ENVIRONMENTAL REVIEW COMMITTEE REPORT

Project Name: MeadowVue Preliminary Plat

Project Number: LUA17-000106, ECF, PP, MOD

Project Summary: The applicant is requesting Preliminary Plat approval and Environmental Threshold Determination (SEPA) for a proposed 14-lot subdivision. The project site is 197,762 square feet (4.54 acres) and is located at 13833 156th Ave SE. The project site is located in the Residential-4 (R-4) zoning designation. The proposed single-family residential lots range in size from 9,633 square feet to 11,313 square feet with an overall proposed density of 3.73 dwellings per acre. One existing single-family dwelling will be removed, along with multiple associated accessory structures. Additional proposed improvements include a storm water tract in the southwest corner of the site along the 154th Ave SE frontage. The proposed lots will be served by a new public residential access street that will connect 154th Ave SE with 156th Ave SE. Proposed lots will be served by sanitary sewer along the new street that will connect to an existing main within 152nd Ave SE. Proposed lots will be served by a new water main extending from 156th Ave SE along the new street. Con

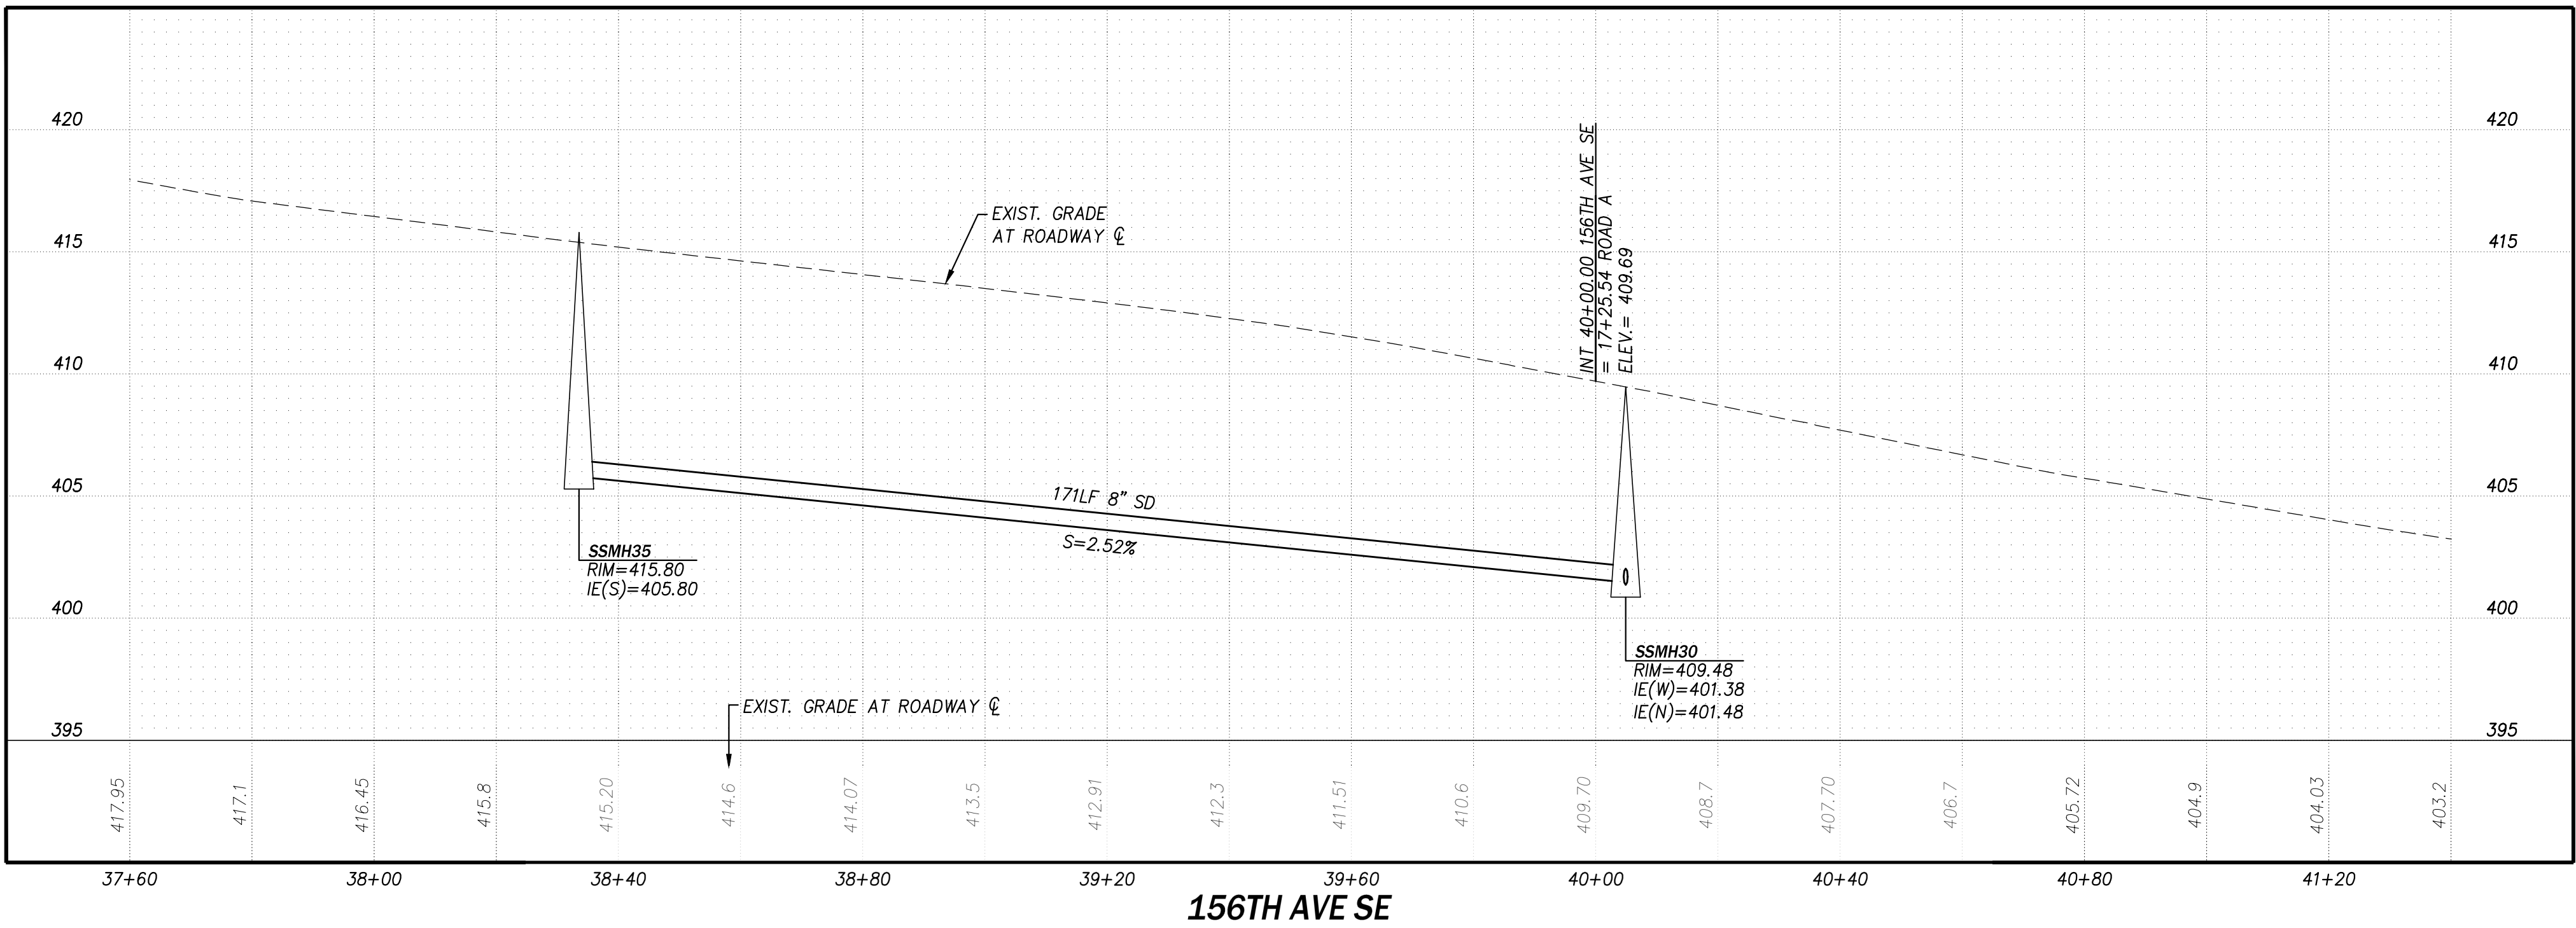
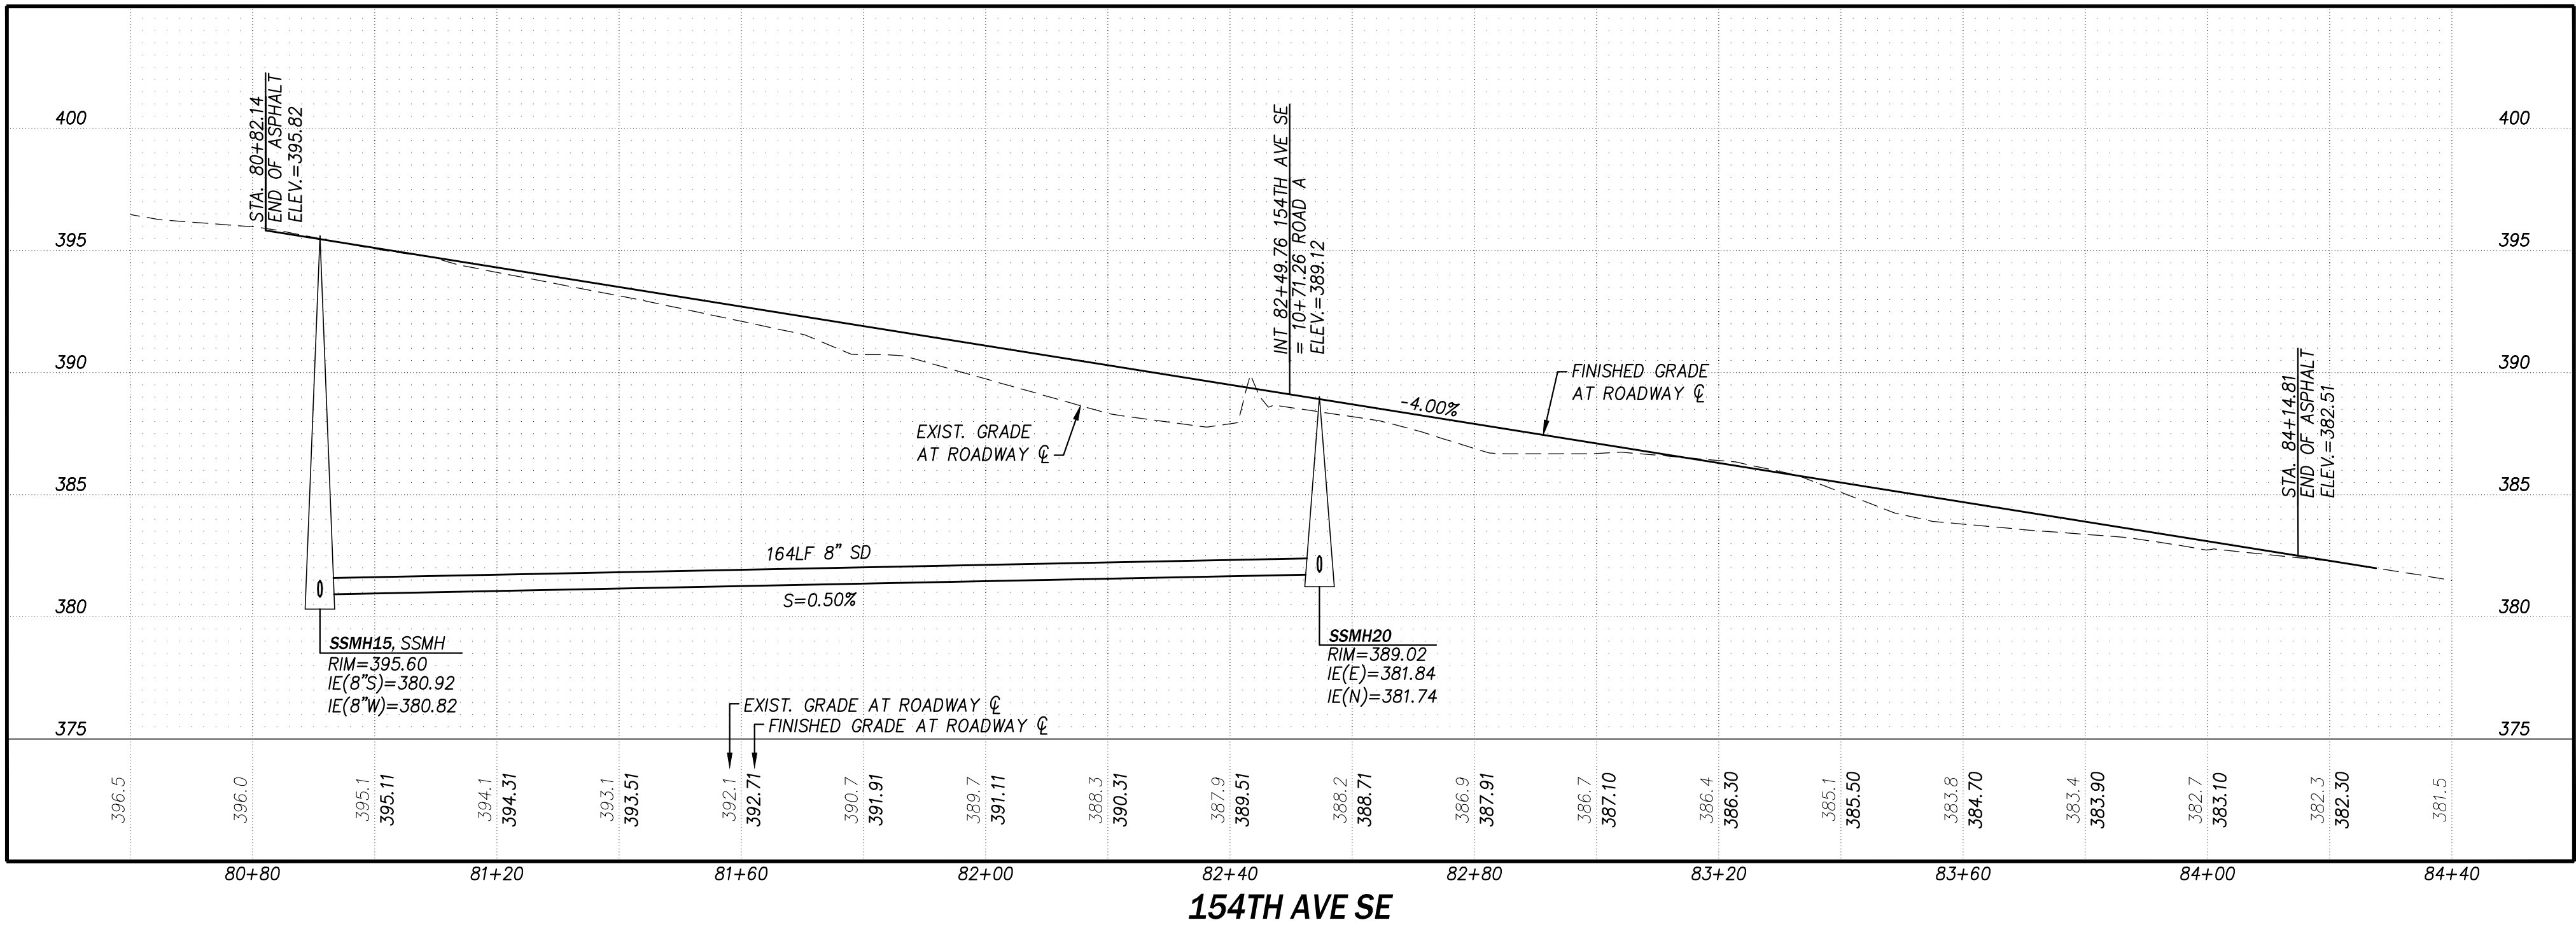
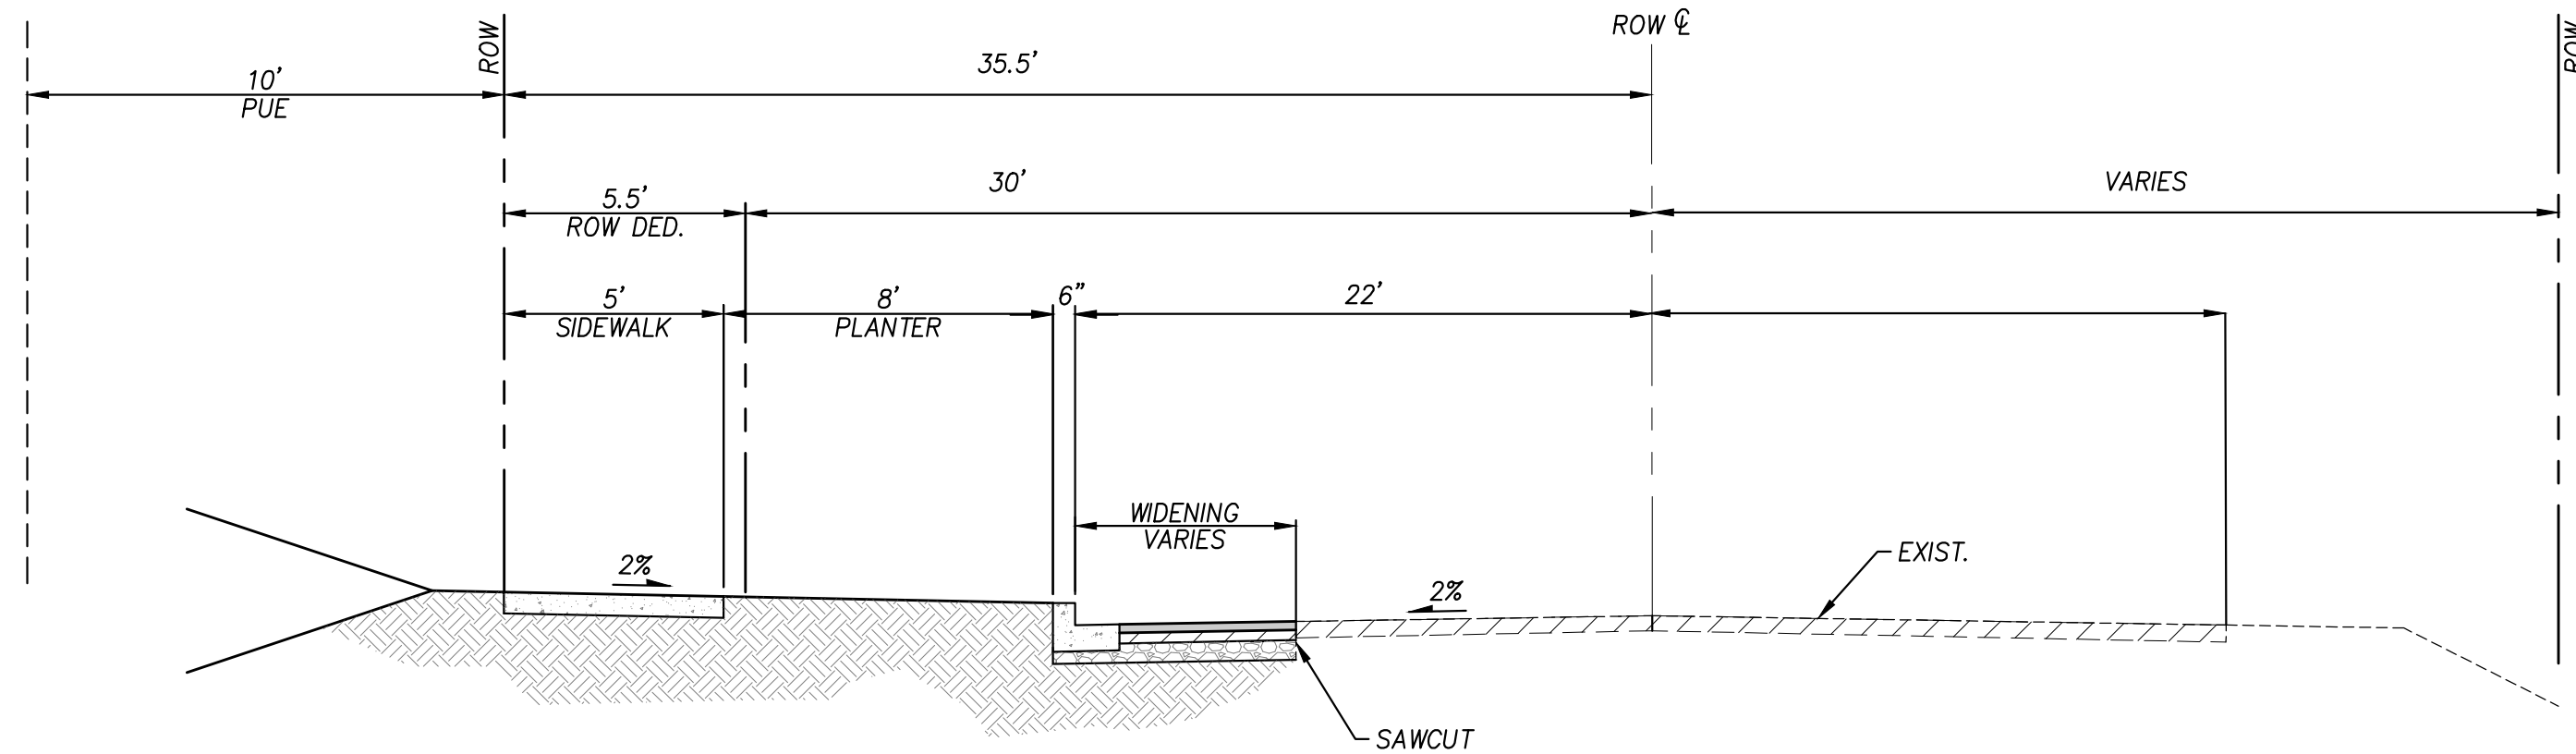
Impacts: Primary access to the site would be provided via a new proposed Residential Access Road from on 156th Ave SE, as shown in the preliminary site plan (*Exhibit 2*). The preliminary road profiles and road sections (*Exhibits 9 & 10*) propose existing and proposed grading and road improvements within three roads; 156th Ave SE, 154 Ave SE, and Road A.

PRELIMINARY ROAD SECTIONS

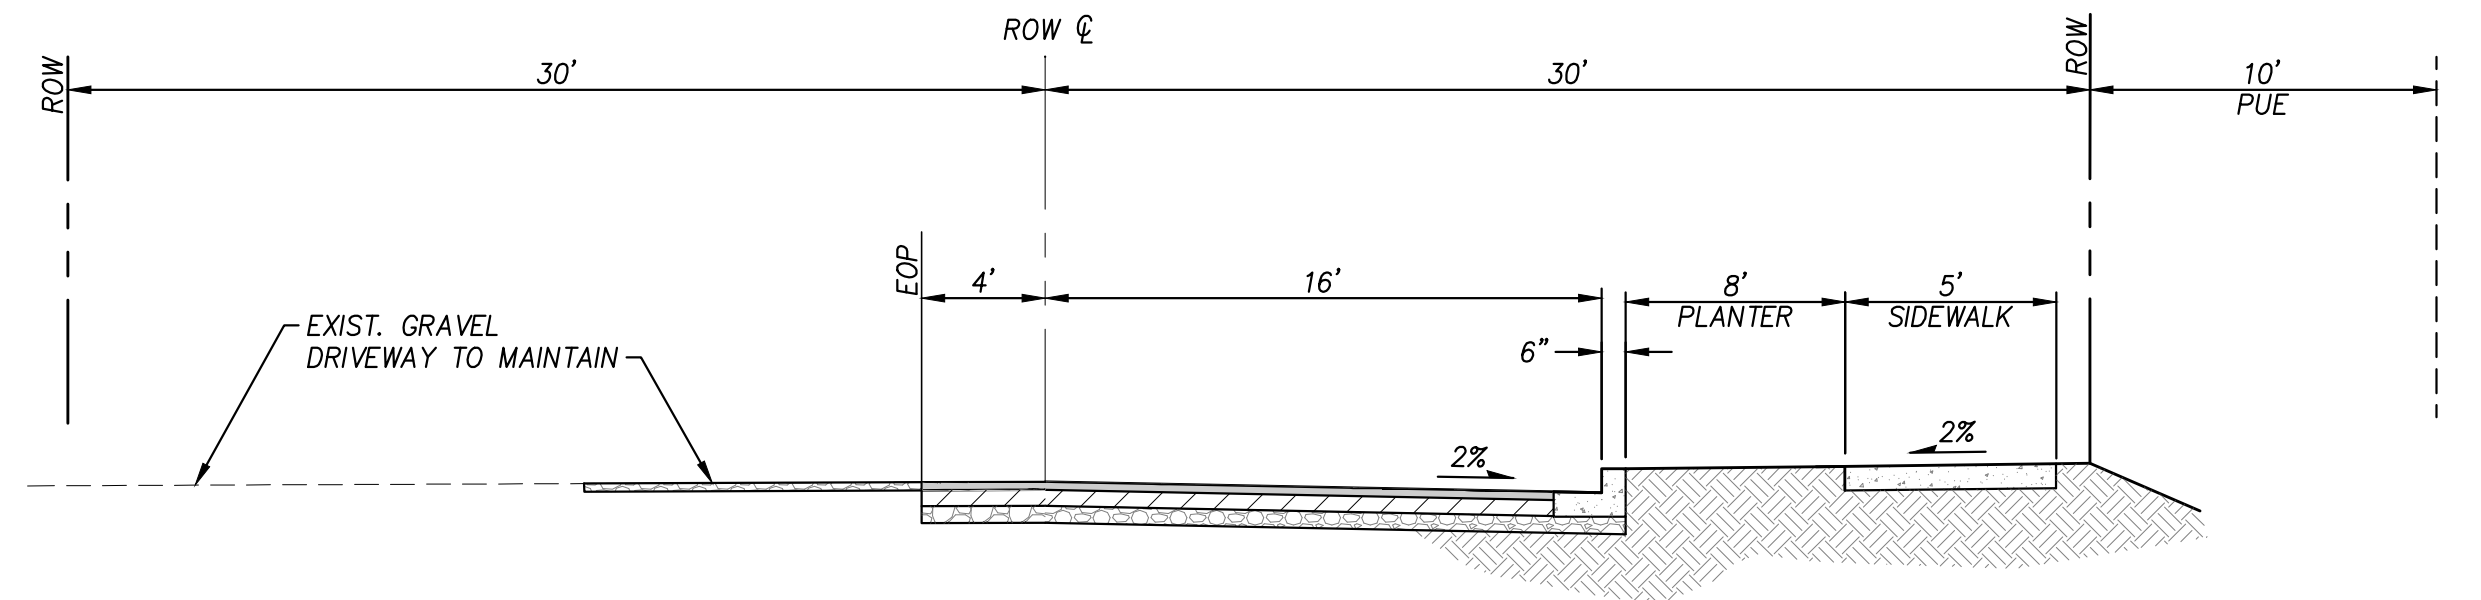
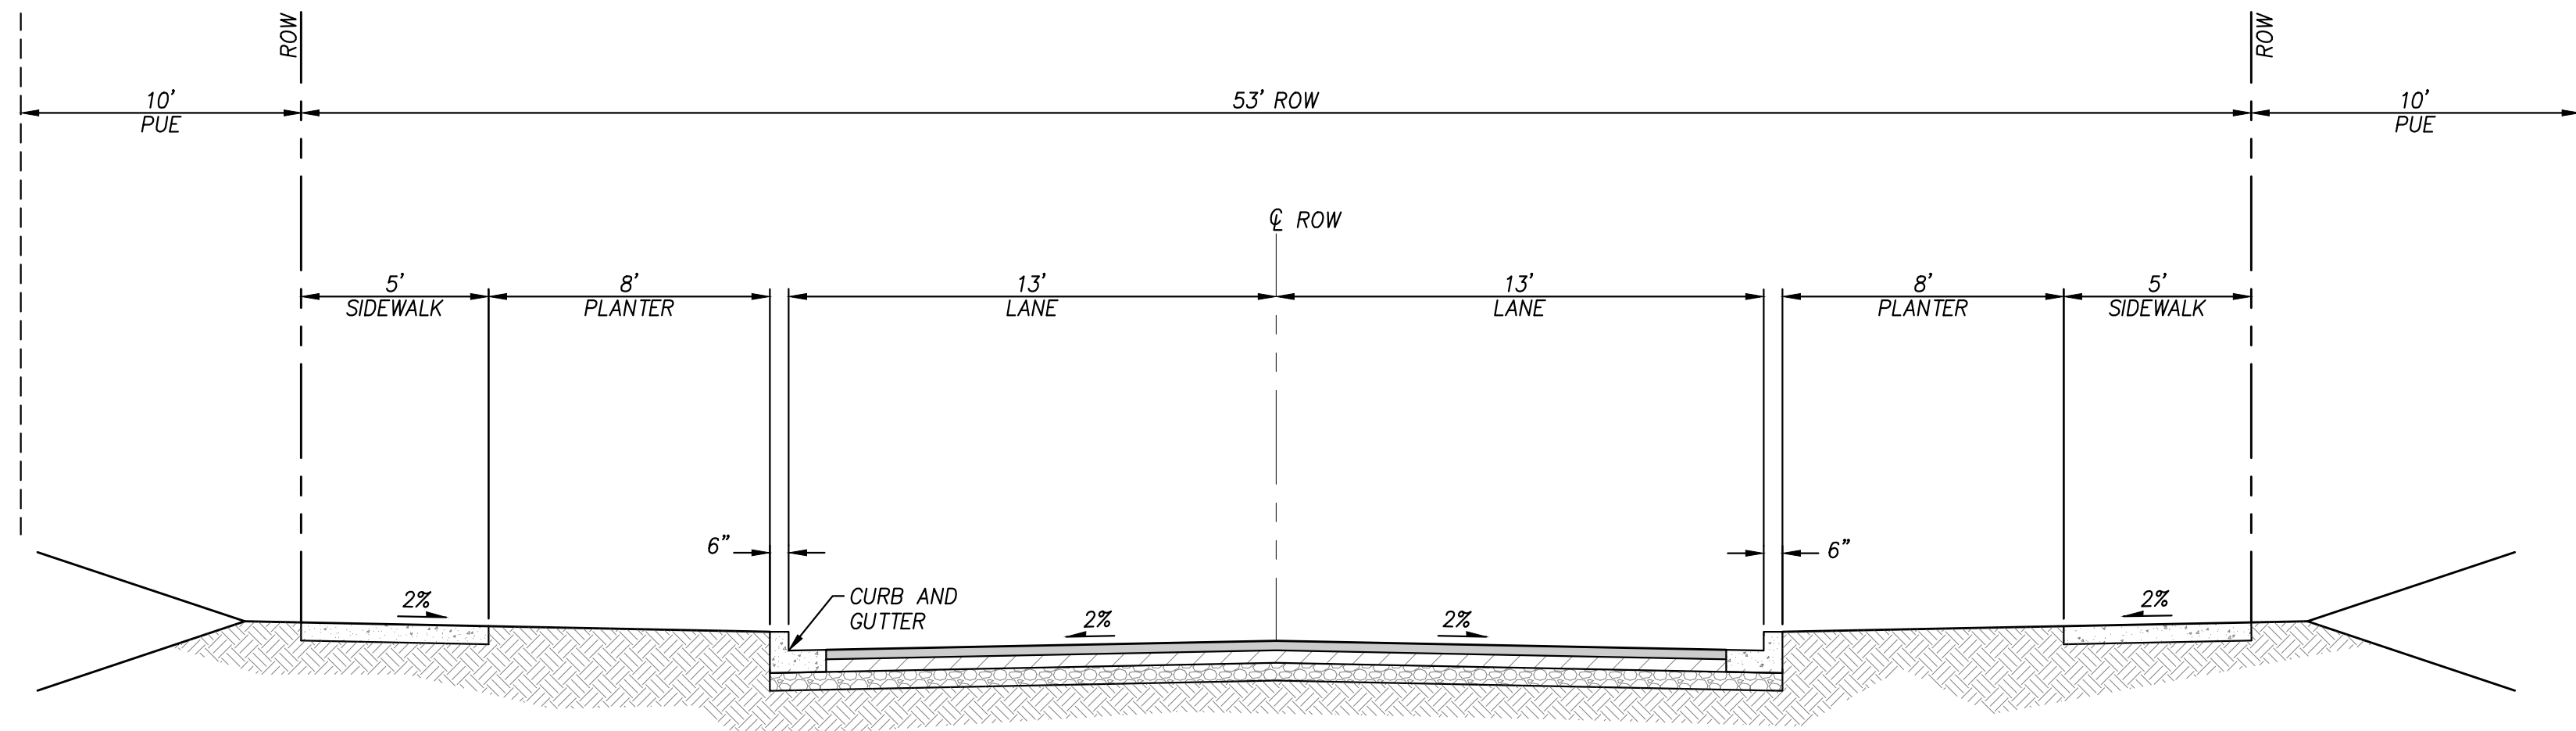
156th Ave SE is classified as a Minor Arterial Road and the existing ROW width is approximately 60 feet. To meet the City's complete street standards, RMC 4-6-060, a minimum ROW width of 91 feet for Minor Arterial Road is required. In addition to the travel lanes a Minor Arterial ROW requires 0.5-foot wide curbs, 8-foot wide landscaped planters, 8-foot wide sidewalks, and 5-foot wide bike lanes. In order to build this street a dedication of 15.5 feet of ROW would be required along the project side of 156th Ave SE. The City of Renton's Transportation Department's plan for 156th Ave SE consist of a cross section with 44-foot paved width, 0.5-foot wide curbs, 8-foot wide planters, 5-foot wide sidewalks. This can be achieved in a total right of way width of 71 feet. In order to build this street section, approximately 5.5 feet of ROW would be required to be dedicated to the City along the

project side of 156th Ave SE. The applicant has submitted a request for a street modification to reduce the width of the ROW dedication from 15.5 to 5.5 feet.

154th Ave SE, located along the west property line, is classified as a Residential Access Road with approximately 60 feet of ROW. To meet the City's complete street standards for residential access roads, the minimum ROW width would be 53 feet, requiring no ROW dedication. As no existing paved roadway exists for 154th Ave SE, a 20-foot paved half-roadway section is required along the project side of 154th Ave SE with a new curb line set 13 feet east of the center of the ROW. Frontage improvements shall include a 0.5-foot wide curb, 8-foot wide planter, and 5-foot wide sidewalk along the project side of the roadway.

The applicant has proposed a new Residential Access Road through the subdivision (Road A). The applicant is proposing a cross-section that includes a ROW width of 53 feet with 26 feet of pavement, 8-foot wide landscaped planters, 5-foot wide sidewalks, and 0.5-foot wide curbs. The roadway would provide two (2) 10-foot travel lanes and one (1) 6-foot parking lane.
